ADDENDUM NUMBER THREE (3)**CATAWBA COUNTY****BLACKBURN RESOURCE RECOVERY FACILITY OPERATOR'S BUILDING****PROJECT NO. 26.00701**

This Addendum Number 3 (Three) is issued this the 28th day of October 2026, to all parties who hold a set of Bid Documents for the project entitled: “**BLACKBURN RESOURCE RECOVERY FACILITY OPERATOR'S BUILDING**”. This Addendum Number 3 (Three) shall become part of the Contract Documents and its receipt acknowledged on the bid documents at the time of bidding.

SHEET TITLE
TYPICAL LIGHT GAUGE FRAMING DETAILS

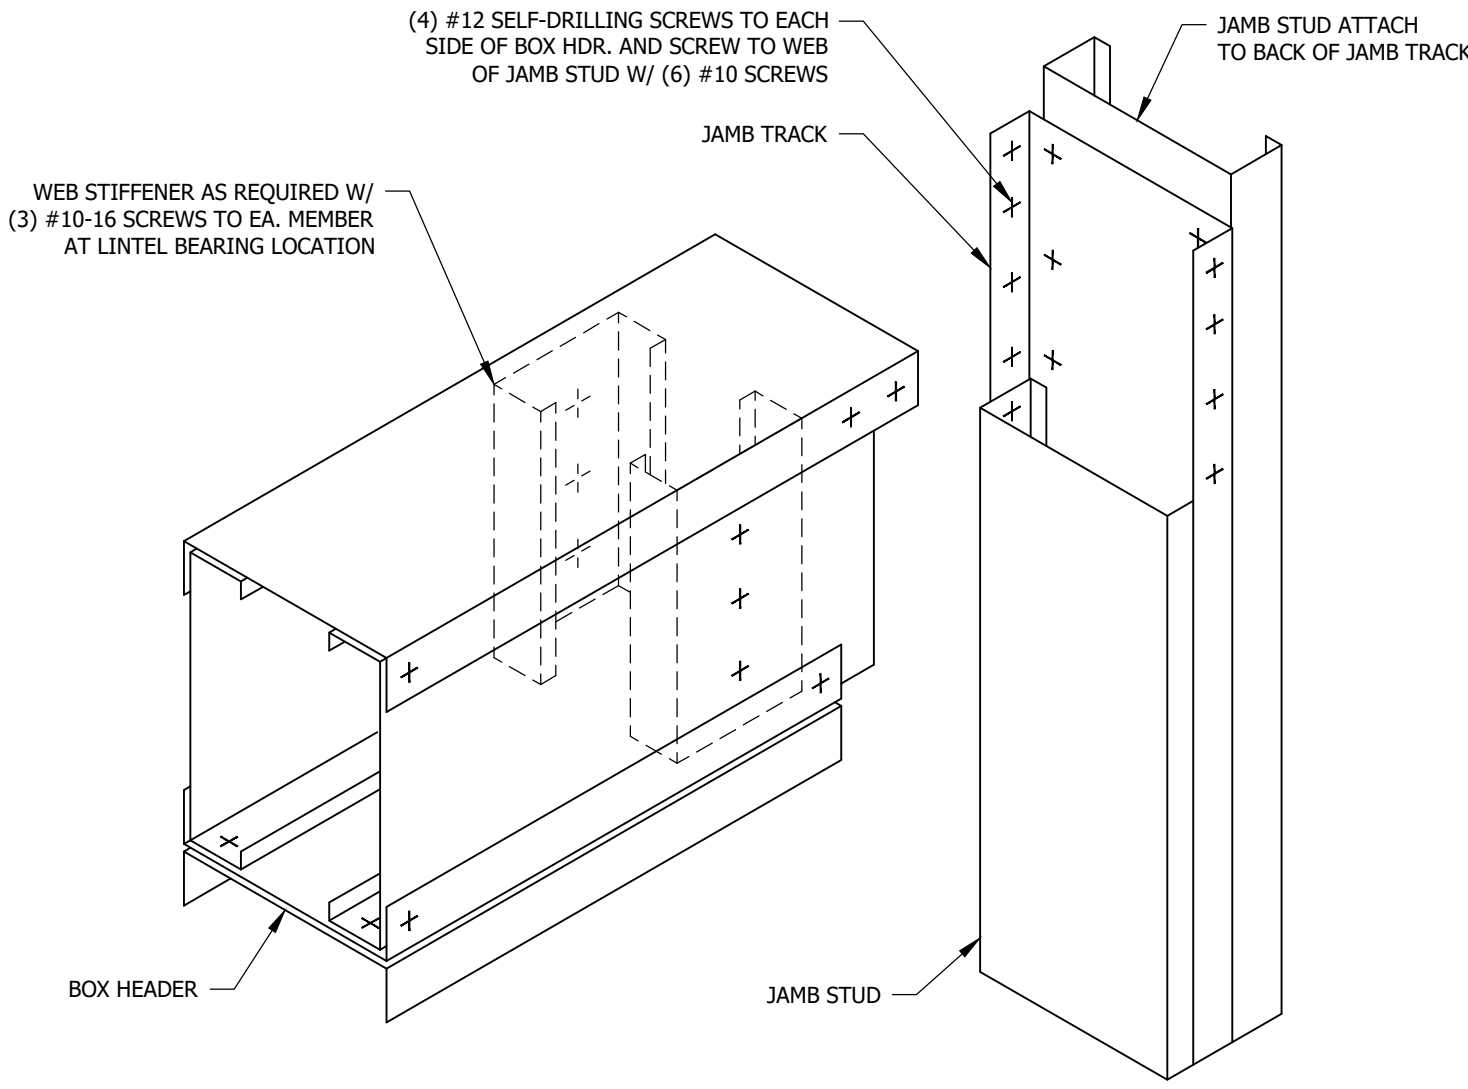
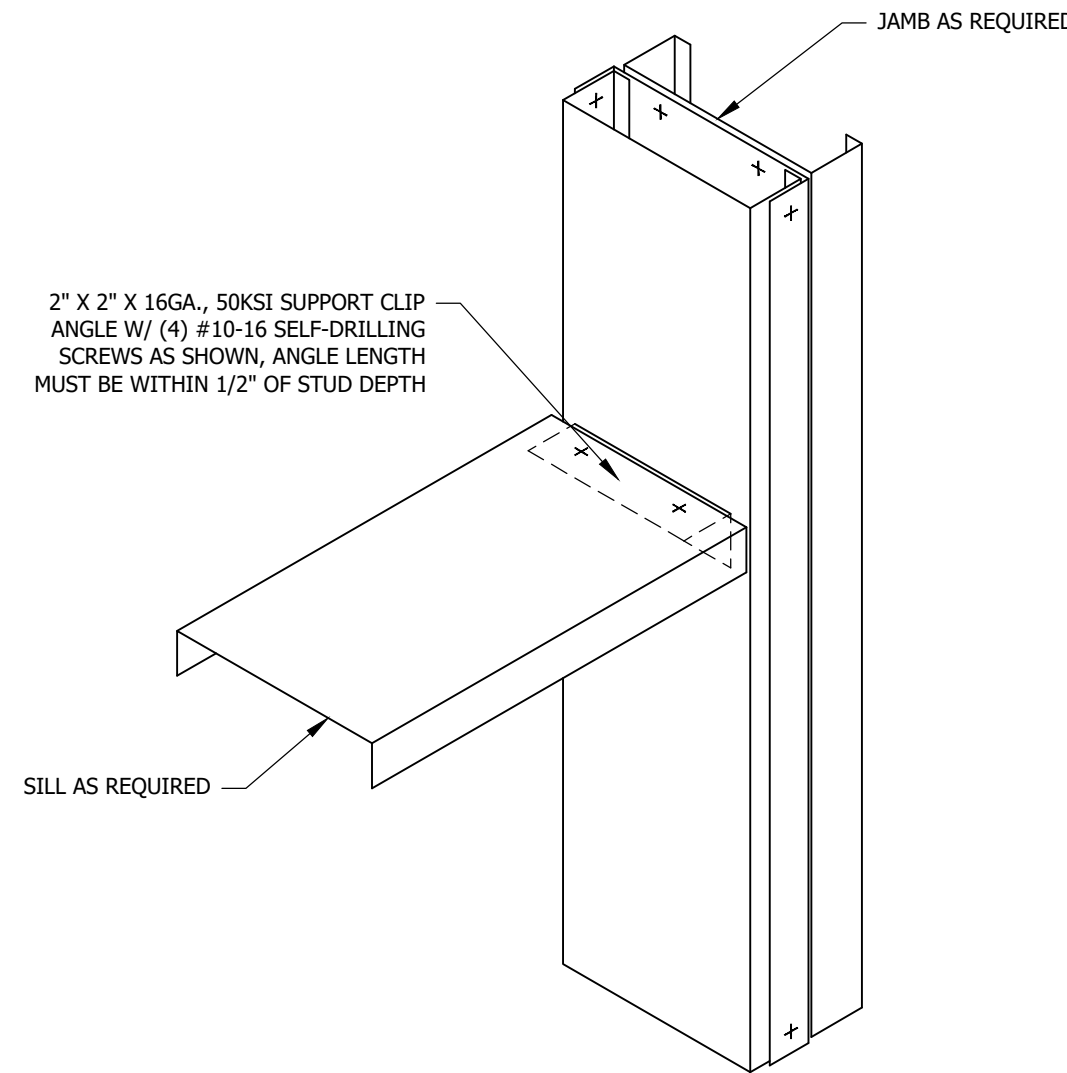
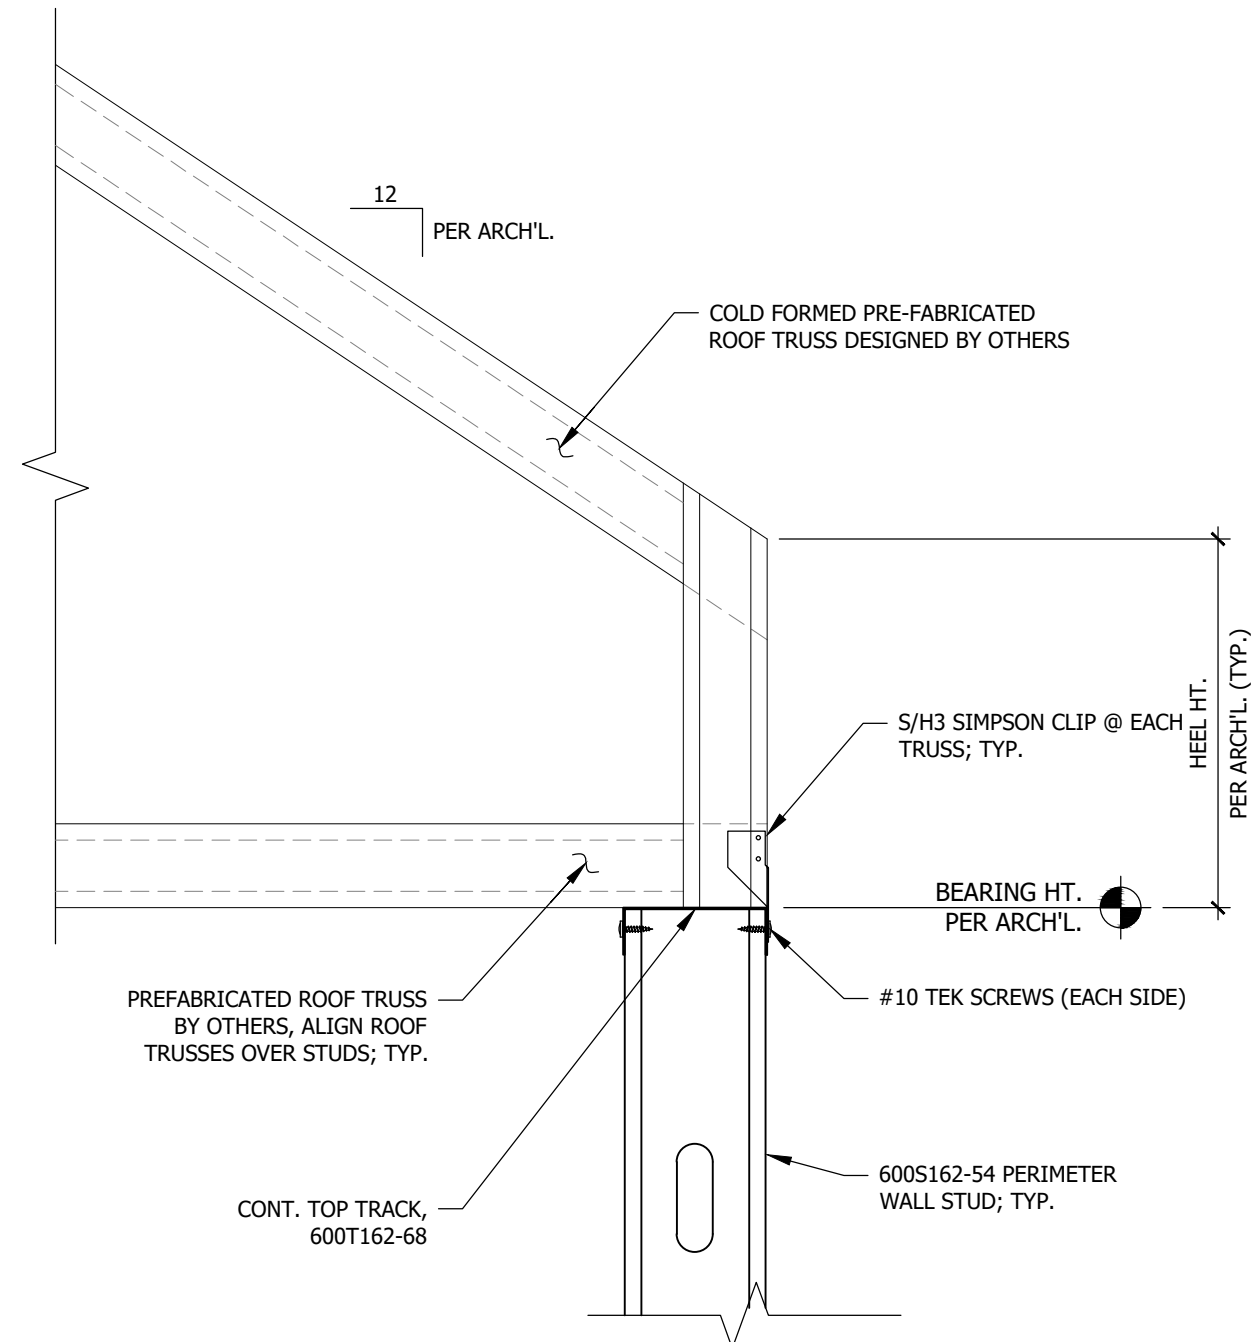
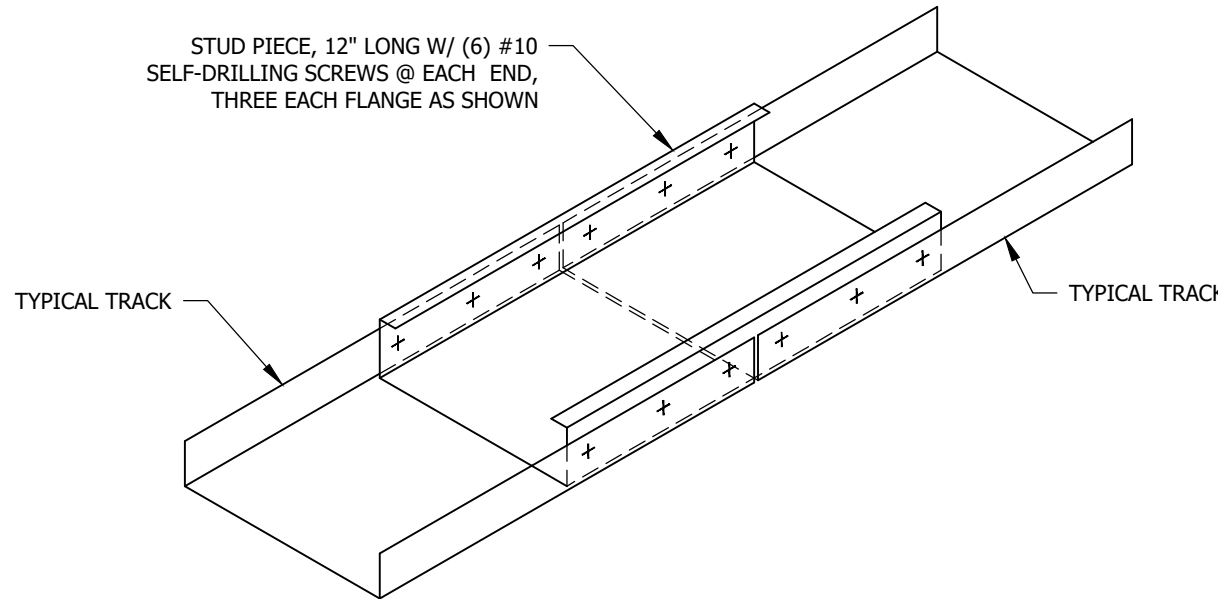
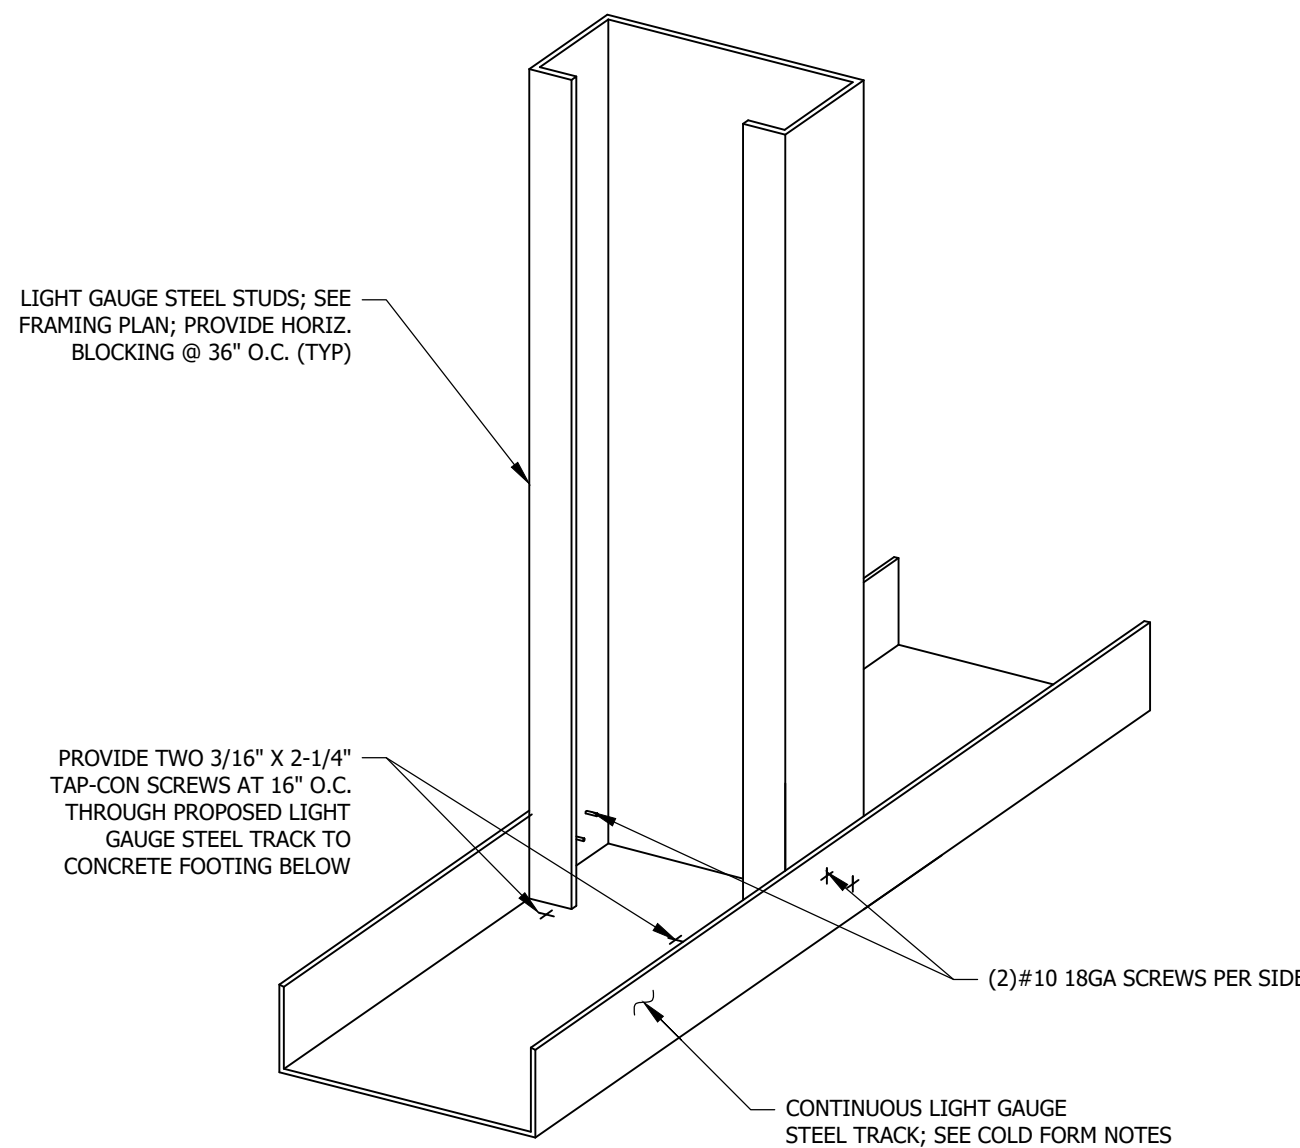
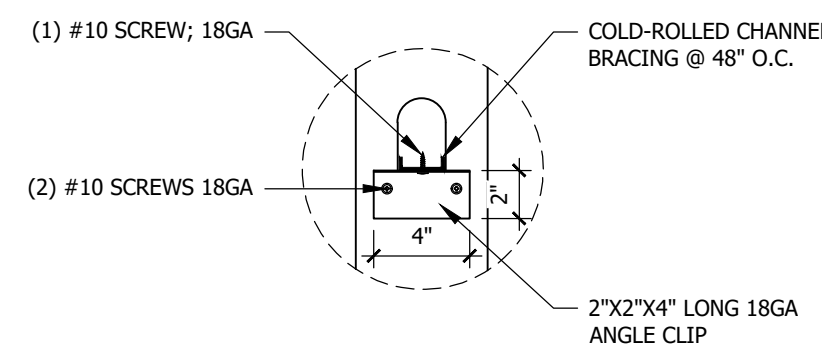
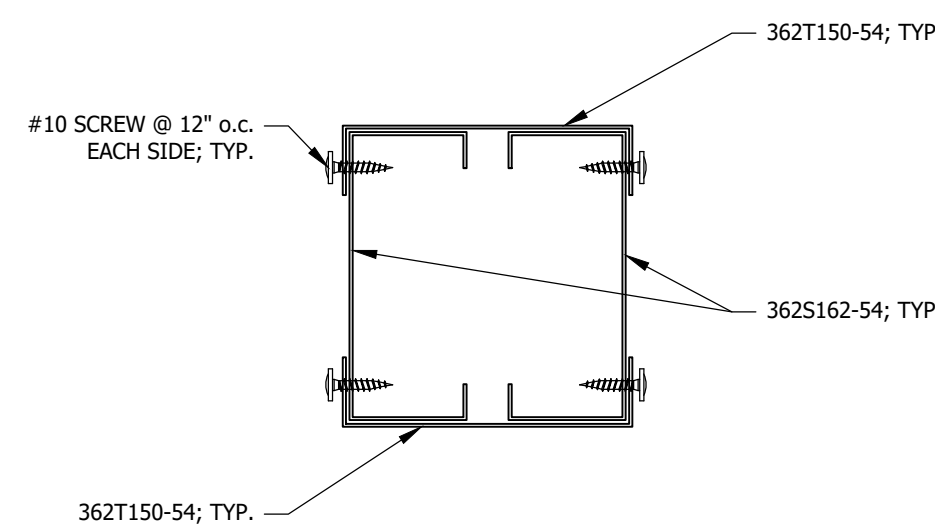
36. Stud-to-track and jamb connection requirements: Please confirm that the structural framing connection details on S002 govern load-bearing CFMF construction, including stud-to-track fasteners and jamb/header configurations, and clarify whether the specification's clip-and-tie language imposes additional requirements. Confirm that

crimped connections under Section 09 22 16 apply only to non-load-bearing partitions. (Reference: S002; Specification 05 40 00, 3.02; Specification 09 22 16, 3.02)

- a. The details on Sheet S002 are intended to cover the CFS typical connections. The Engineer of Record will need to review the truss shop drawings.
37. SFIA certification and installer qualifications: Section 054400 requires SFIA-accredited contractors and fabricators, along with installer certification documentation. Please confirm whether these qualifications are mandatory for roof truss installation or whether equivalent qualifications will be accepted. (Reference: Specification 054400, 1.05(D) and 1.06)
